ITEM FOR ENVIRONMENTAL BOARD AGENDA

**NAME & NUMBER
OF PROJECT:** WEBB ESTATES
C8J-2008-0082

MEMORANDUM

SUBJECT: Webb Estates C8J-2008-0082

WEBB ESTATES
PRELIMINARY PLAN
SLOPE MAP - TURKEY CREEK WATERSHED

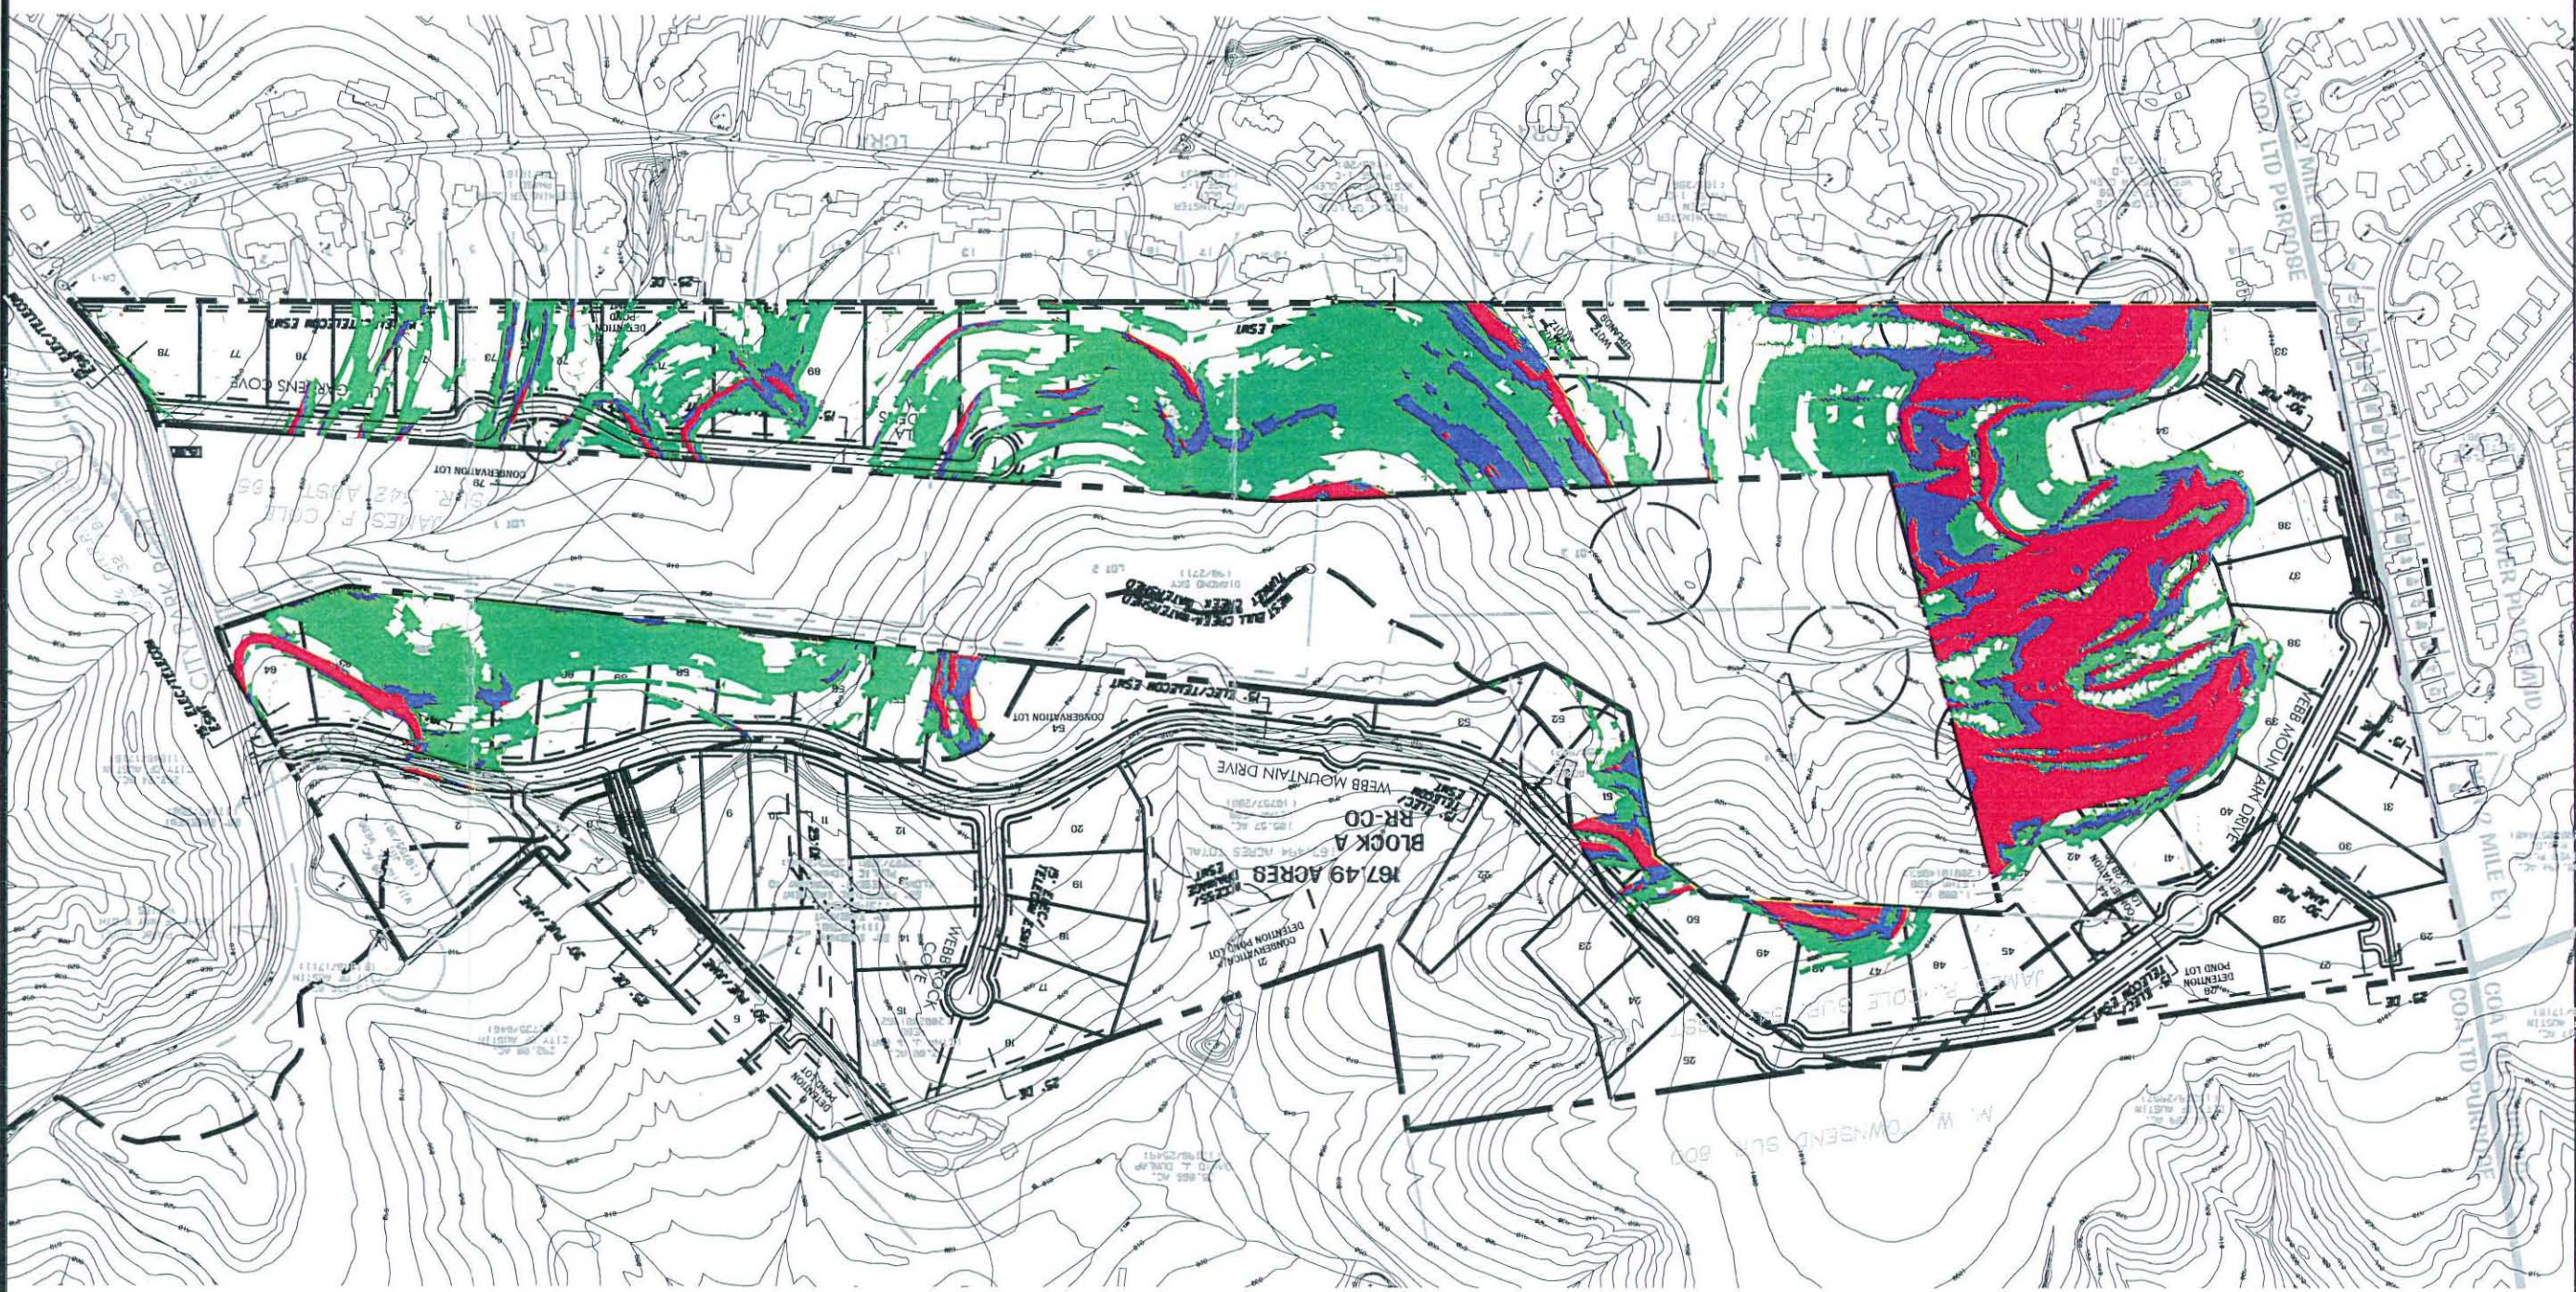
1. Variance from City Code Section 30-5-301(A)- Construction of roadway and driveways on slopes > than 15%.

This variance is required to allow construction of portions of the two roads accessing the subdivision and driveways on lots where the driveway must cross slopes over 15%.

Both of the proposed roads cross slopes greater than 35%. Since a watershed boundary literally traverses across this property, it is located at the very top of two watersheds. At the top of these Hill Country watersheds, most drainage ways are narrow steep sided ravines carved into the weathered limestone. Both of the proposed roads cross several of these narrow steep sided ravines to gain access to proposed lots. Additionally, the location of these roads is somewhat restricted due to topography of the land and the locations of the CEFs.

The applicant is also requesting this variance to allow for construction of driveways on lots where the driveways must cross slopes greater than 15% to access the building site. The lots for which this variance is requested are Lots 1-5, 7-20, 22-25, 34, 36, 38, 39, 42, 43, 46-51, 53, 55-64, 66-76.

2. Variance from City Code Section 30-5-302(B)- Construction of a building on slopes greater than 25%.

This variance is requested to allow for homes to be constructed on Lots 1-5, 7-20, 22-25, 34, 36, 38, 39, 42, 43, 46-51, 53, 55-64, 66-76, all of which have building areas with slopes greater than 25%. Most of these lots are composed of the typical stair-step topography found in the western Travis County Hill Country, and have small areas with slopes greater than 25% in the areas best suited for building placement.

- 1 All slopes greater than 33% shall be stabilized with a permanent structure, unless it is a stable rock face;
- 2 All disturbed areas shall be revegetated with City of Austin 609-S specification;

- 5 Implement a City approved Integrated Pest Management Plan;
- 6 Any fill greater than 4 feet will be structurally contained;
- 7 Provide slope related building setbacks on each lot to further protect the steeper portions of each property;

- 9 For all lots in which construction occurs on slopes greater than 25%, flow spreaders will be used to ensure storm water leaves the site in sheet flow conditions.

WEBB ESTATES (C8J-2008-0082) CUT & FILL VARIANCE REQUEST EXHIBIT

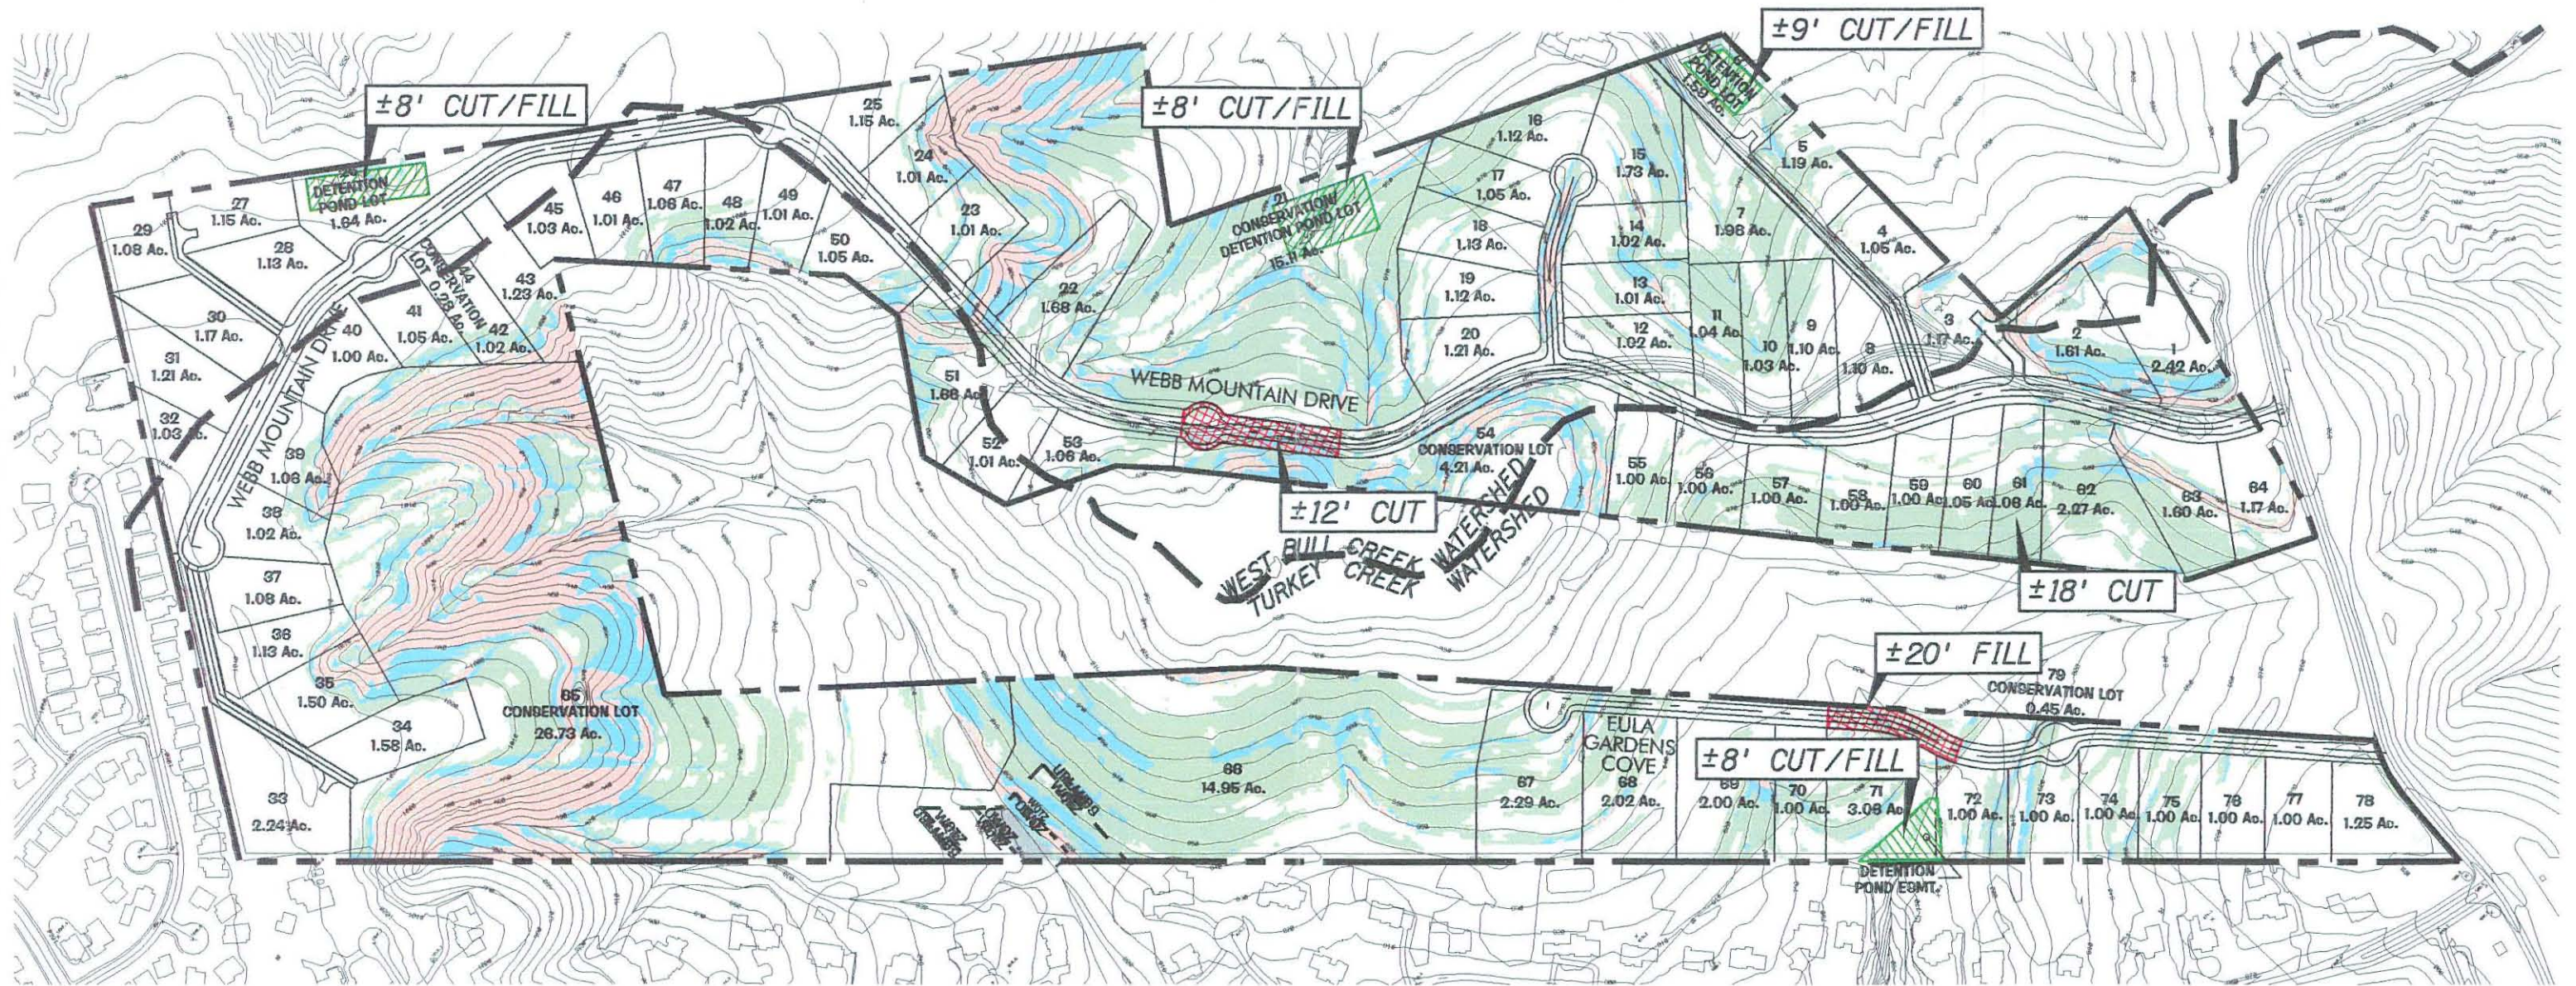
3. Variance from City Code Section 30-5-341- Cut greater than 4 feet. Variance from City Code Section 30-5-342-Fill greater than 4 feet.

This cut/fill variance is requested to allow the applicant to construct the detention ponds and roadways, and to later on allow the lot owners the ability to construct driveways and suitable building sites.

The applicant will need a maximum cut/fill of 9 feet to construct the four detention ponds.

The applicant will need this cut/fill variance to complete the central sections of both roads accessing the lots in this subdivision. On Webb Mountain Drive, the maximum proposed cut/fill is 12 feet. On Eula Gardens Cove, the maximum fill proposed is 20 feet.

Cut/fill will be necessary to construct driveways and/or single family residential buildings on individual lots where either the driveway must cross steep slopes, or on building sites which are located on the steeper bands of this Hill Country topography. Because home builders, not the applicant, will be locating and building the homes and associated driveways in this subdivision, the applicant is not certain of the exact location of each home. As a result, the applicant has estimated the cut/fill necessary for those lots that will require cut/fill to build the home. The applicant shows that Lots 2, 5, 7, 9-17, 22-24, 51, 53, 55-63, 66-76 need cut/fill greater than four feet to construct the home. The maximum cut/fill of 18 feet is requested for Lots 7, 22, 63, and 75.
